Re: VEHICULAR CROSSING TO A DWELLING AT 4050 PRICE STREET
ITEM 20, MANAGER'S REPORT NO. 44, COUNCIL MEETING JUNE 28, 1976

ITEM	3
MANAGER'S REPORT NO.	78
COUNCIL MEETING	Dec. 6/76

RE: VEHICULAR CROSSING TO A DWELLING AT 4050 PRICE STREET
ITEM 20, MANAGER'S REPORT NO. 44, COUNCIL MEETING JUNE 28, 1976

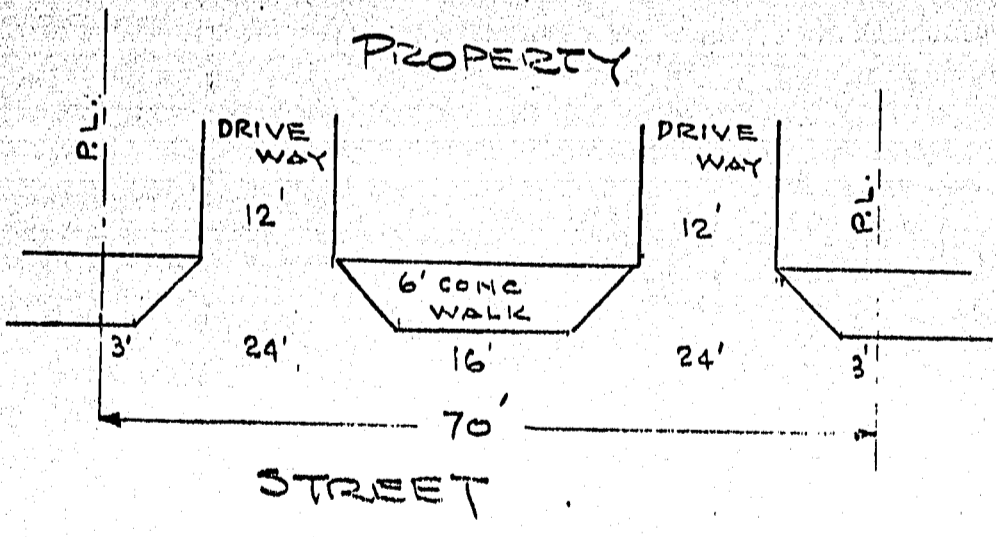
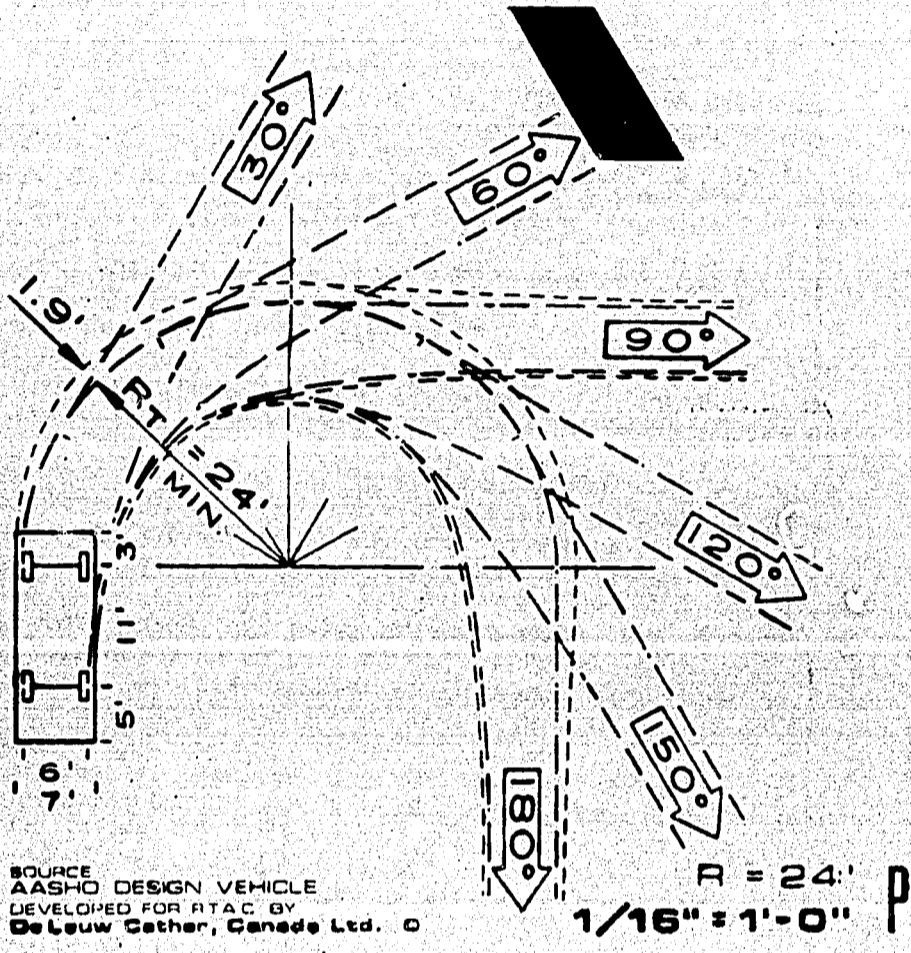
We have been requested to consider the above policy Item 7 to determine whether we could reduce the width of the frontage and presumably still have a functional loop driveway. Attached to this report is a sketch layout of the turning characteristics of a standard passenger car as suggested by the Road and Transportation Association of Canada. Using this as a standard, we could reduce the width of the frontage to 70 feet (4050 Price is 70.9 feet) and still have a functional loop. However, as noted in policy Item 7, the main reason for the 80 foot limit was an attempt to reduce the number of vehicle crossings over the public sidewalk. As an example, we would advise that of the 28 properties on Price Street between Patterson and Smith Avenues, 25 would be eligible for loop driveways while under an 80 foot limit only 13 would be

eligible. While it could be argued that a 70 foot limit would not affect older areas too much because of smaller lot sizes, many of our newer areas are comprised of lots between 70 and 80 feet in width, i.e. area bounded by Winston, Lougheed, Phillips and Brighton Avenue where the vast majority are over 70 feet but under 80 feet.

In view of the above report, we are still of the opinion that the original intent of Item 7 of the policy is valid.

THAT Item 7 of the existing policy related to loop driveways be upheld.

PLOT PLAN
SCALE: 1" = 20'

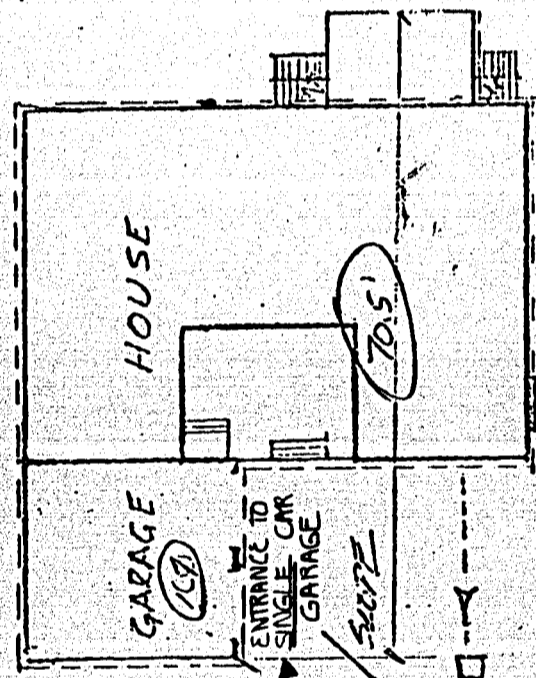
NOTE: MR. MARTIN IS CON-
STRUCTING A CARPORT
AT THIS APPROXIMATE LOCATION

THIS IS AN EXISTING
CROSSING WHICH ACCORD-
ING TO THE POLICY
SHOULD BE REMOVED.

THIS IS THE CROSSING THAT IS
NEEDED TO GAIN ACCESS TO THE
GARAGE. IT HAS NOT YET BEEN
CONSTRUCTED.
